MISSISSIPPI POWER & LIGHT COMPANY

January 15, 1982

SUBJECT: Grand Gulf Nuclear Station
Units 1 and 2
Docket Nos. 50-416 and 50-417
File 0262/0472/L-860.0/L-401.0
Status of Evaluation of IE Bulletin 79-14
Ref: AECM-79/122 dated October 31, 1979
and AECM-81/212 dated August 11, 1981
AECM-81/474

FIGURE 1
RESPONSE TO NRC FOLLOW-UP ITEM 416/81-37-02

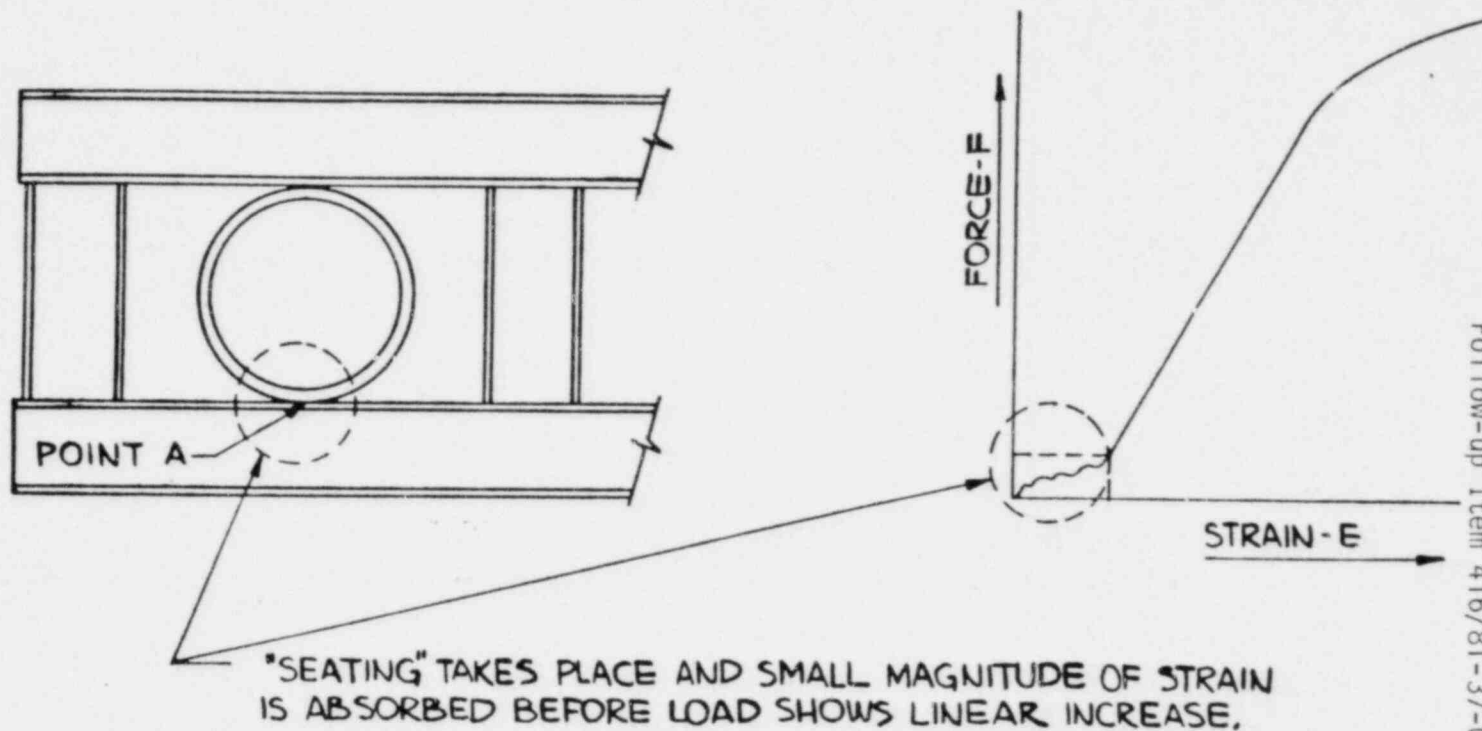
Bechtel Specification 9645-MS-16, Paragraph 2.6.3 allows piping with operating temperatures less than 150°F to have a zero gap with pipe supports. Normal construction and inspection practices, however, indicate that the support inspections were normally performed subsequent to field fabrication and installation of the pipe support. Consequently, the inspection would not identify any stresses that could have been induced during field fabrication and installation of pipe supports with zero clearance. A/E agreed to study the question and provide a resolution.

Per Bechtel document No. 9645-MS-16, zero gap between piping and pipe support is allowed only when the maximum operating temperature of the system is less than 150°F. Our justification for allowing zero gap is as follows:

1. The radial expansion of piping and the shrinkage of weld material during installation creates a strain which is very small in magnitude. The resulting clamping forces are insignificant.

2. The theoretical clamping force associated with this small magnitude of strain is realistically decreased due to the inherent flexibility of the two components in contact (i.e., pipe and the flange of the pipe support structural steel member).

3. The axial movement of low temperature systems at box type restrains will generally be very small thus creating small loads due to the clamping effect. This is particularly true when the axial movement is along the weak axis of the associated support steel member, which usually is the case.

4. Thermal stresses which would result from zero gap are secondary in nature and thus self-relieving.
5. In any loaded assembly a certain amount of strain will take place before the system starts to exhibit linear loading characteristics. This phenomenon is shown in Figure 1 and is caused by surface roughness and any out-of-flatness (or roundness) of the parts in contact.

CLAMPING FORCE DEVELOPED AT POINT A DEPENDS ON:

- (1) MAGNITUDE OF STRAIN
- (2) FLEXIBILITIES OF SUPPORT STEEL AND PIPE
- (3) SURFACE CHARACTERISTICS OF PIPE AND SUPPORT STEEL
